Department of Energy
Carlsbad Field Office
P. O. Box 3090
Carlsbad, New Mexico 88221

Subject: Response to Environmental Protection Agency Letters Dated December 17, 2014 and February 27, 2015 Regarding the 2014 Compliance Recertification Application

In response to the U.S. Environmental Protection Agency (EPA) 2014 Compliance Recertification Application completeness review letters dated December 17, 2014 and February 27, 2015, the U.S. Department of Energy (DOE) is providing responses to 22 of EPA's completeness questions. The DOE will continue to submit phased responses to the EPA to ensure questions are answered in a timely manner, although some items will require additional analysis.

Figure 1 Plan View of WIPP Underground Facility and Panel Closure Systems.

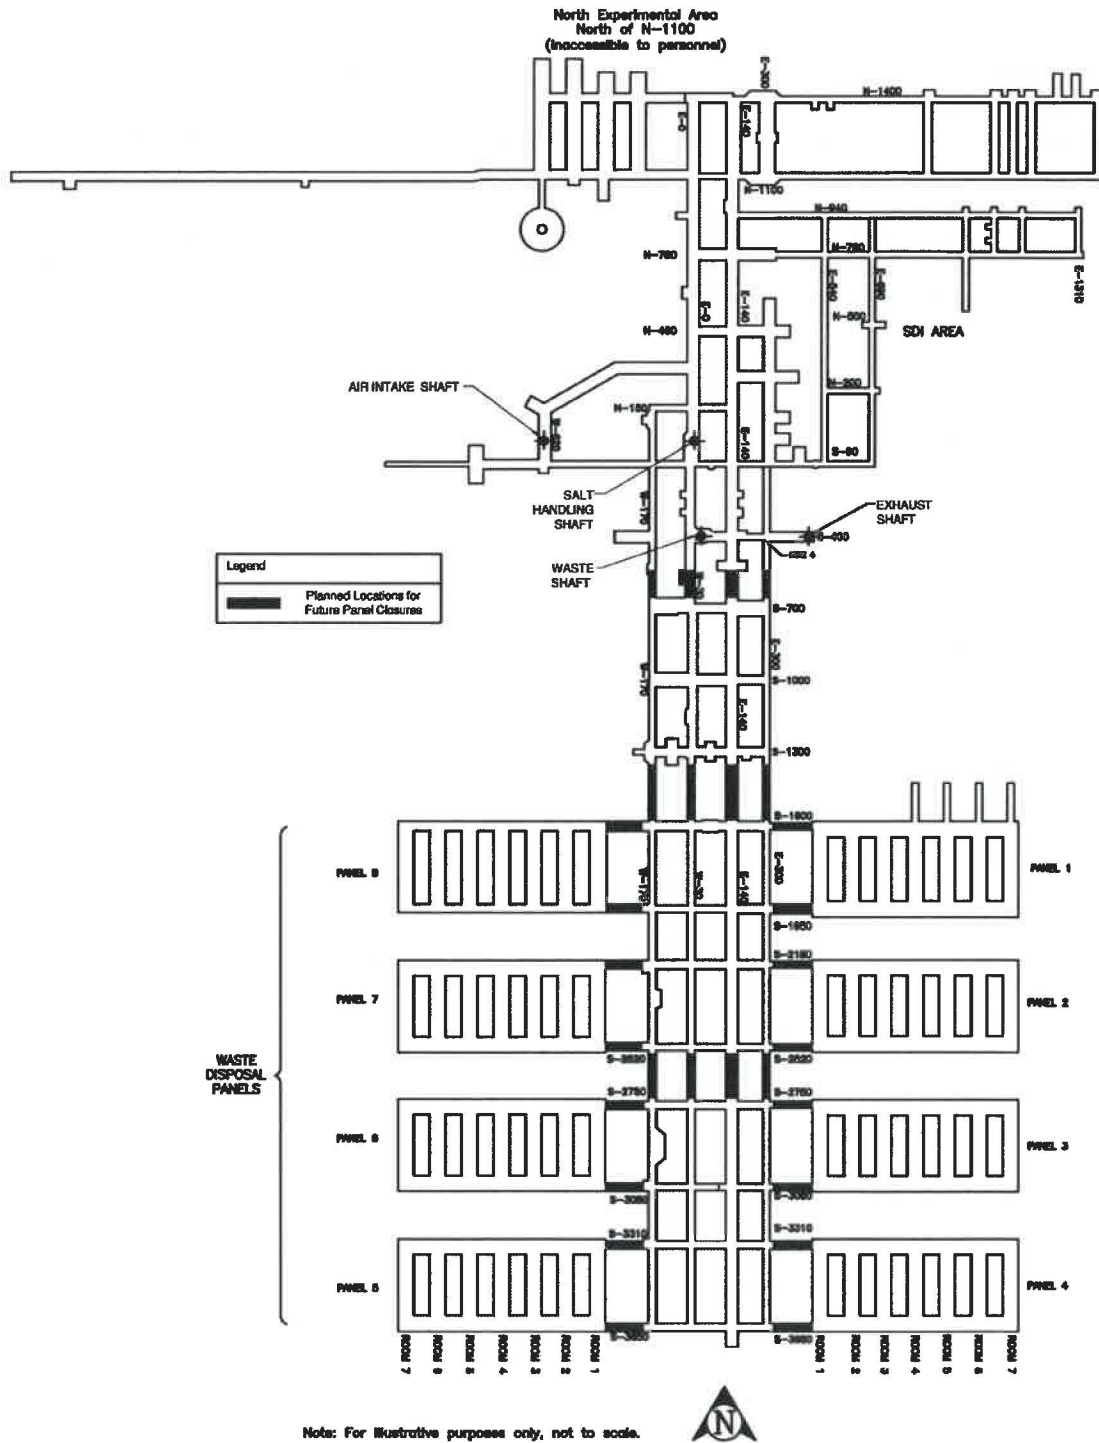
Please provide the WIPP configuration layout (a plan view) used for the 2014 CRA that includes all locations where the ROM salt panel closures are to be placed. Provide text that provides the exact location, dimensions and properties for the set of panel closures that lie furthest north in the repository.

A plan view of the WIPP configuration layout used for 2014 CRA calculations was included as Figure 3-2, Plan View of WIPP Underground Facility and Panel Closure Systems, in the EPA's Approval of the ROM Salt Panel Closure System (ROMPCS) (U.S. EPA 2014). The figure (included here as Figure 1) provides locations where the ROM salt panel closures are to be placed. This is consistent with current WIPP project planning. Panel closures will have the same basic properties as the closures approved by EPA (U.S. EPA 2014) for the panels in Panel Closure System Design (DOE 2011).

The northernmost panel closures would be located in north-south access drifts W-170, W-30, E-140 and E-300 just north of S-700 and just south of the waste and exhaust shafts. The approximate dimensions of the access drifts for the closures are as follows: W-170 – 16 feet wide, 13 feet tall, ROM salt length 100 feet. W-30 – 20 feet wide, 14 feet tall, ROM salt length 100 feet. E-140 – 24 feet wide, 18 feet tall, ROM salt length 100 feet. E-300 – 13 feet wide, 16 feet tall, ROM salt length 100 feet.

Figure 1. Diffusive mixing in the lateral direction provides high CO₂ concentrations near the MgO supersacks. This figure is based on the actual waste emplacement and supersack configuration in the air exhaust drift for Room 7 of Panel 7.

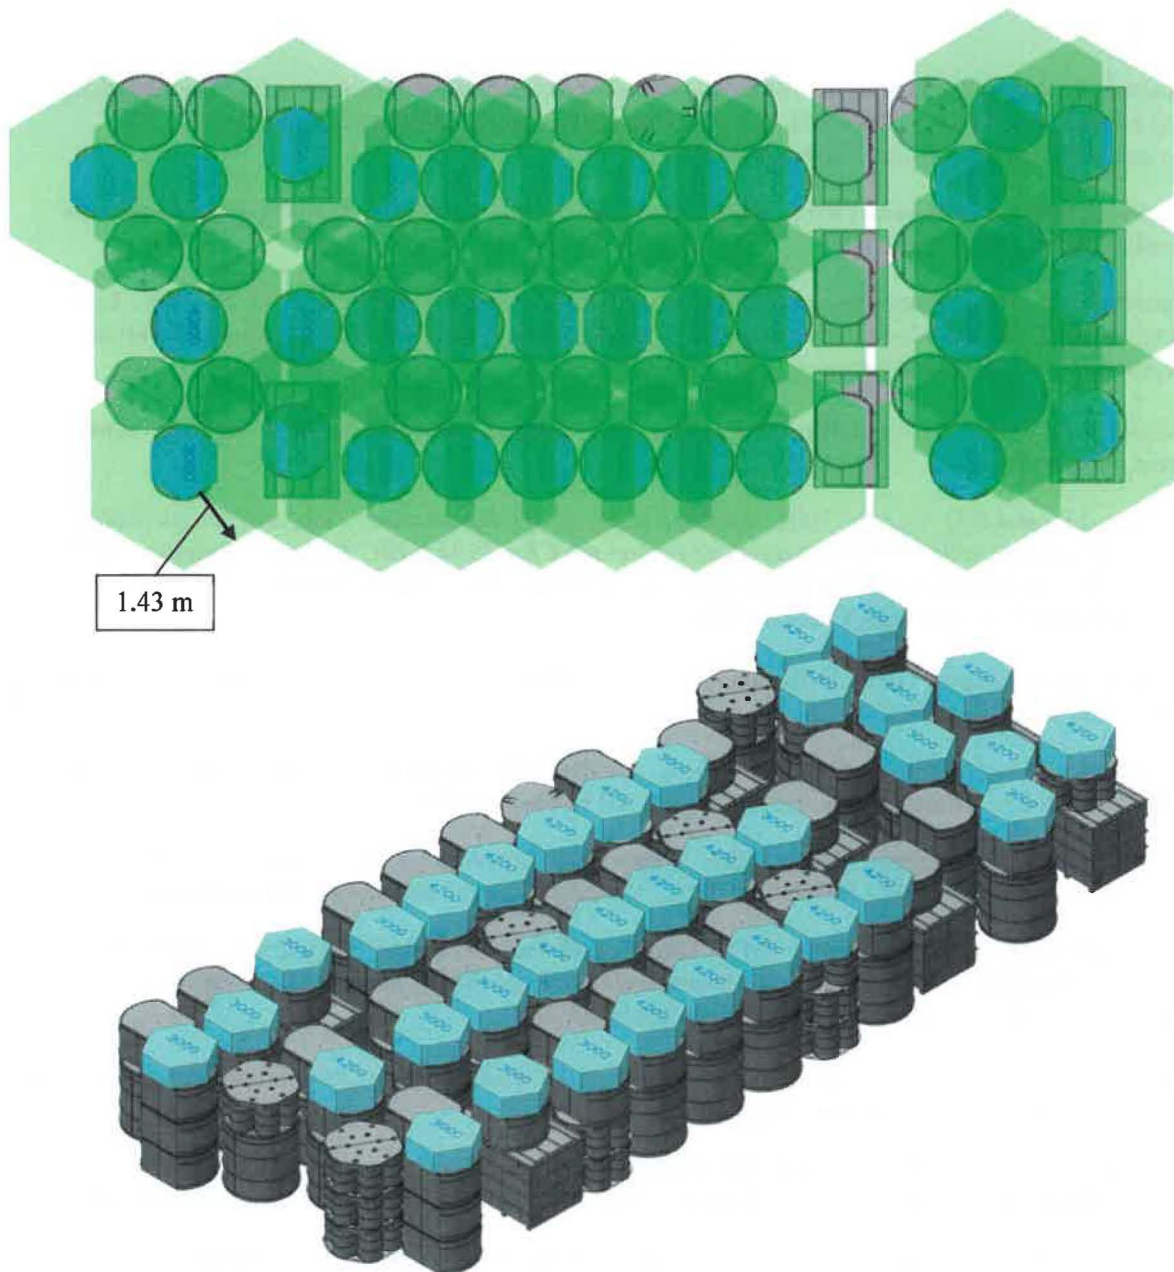
In Franco (2012) DOE notified EPA that MgO emplacement has been modified by placing a 3,000 pound supersack of MgO on every other waste stack or on each waste stack in every other row. In the Franco 2012 letter the "effective diffusion penetration length of CO₂" was considered but the information on physical segregation is limited.

Please provide updated documentation to more explicitly and clearly address whether the larger lateral separation distance still allows sufficient reactions between MgO and CO₂.

Figure 1 illustrates the lateral coverage provided by MgO supersacks for an actual waste emplacement scheme. Figure 1 is based on the as-emplaced waste containers in Room 7 of Panel 7. Room 7 is only partly filled with waste, but provides a realistic example of supersack emplacement for a variety of waste container types with varying lateral separations between adjacent waste stacks. The light green regions surrounding each supersack of MgO illustrate the diffusive penetration length of 1.43 m for CO₂, and the darker green regions indicate where there is overlap from two supersacks. The dissolved CO₂ that is generated by waste containers within the green regions is within the minimum distance L that provides efficient diffusive mixing of CO₂ with MgO supersacks during the minimum hydraulic residence time for the R1S2 scenario in BRAGFLO. Figure 1 shows that the minimum diffusive penetration length of 1.43 m provides efficient lateral mixing of CO₂ over all of the waste containers in Room 7. In addition, lateral diffusion and mixing of dissolved CO₂ is enhanced by: (1) the supersacks will fail during room closure, allowing some MgO to fall into the lateral separation between adjacent waste stacks and accumulate on the floor, (2) channels are likely to exist within the consolidated waste after the drums collapse, providing higher porosity pathways for diffusion of CO₂ in brine, and (3) if the waste is not fully saturated, gaseous diffusion provides a mechanism that rapidly mixes gaseous CO₂ over panel-scale distances². These effects provide added assurance of efficient lateral mixing throughout each room.
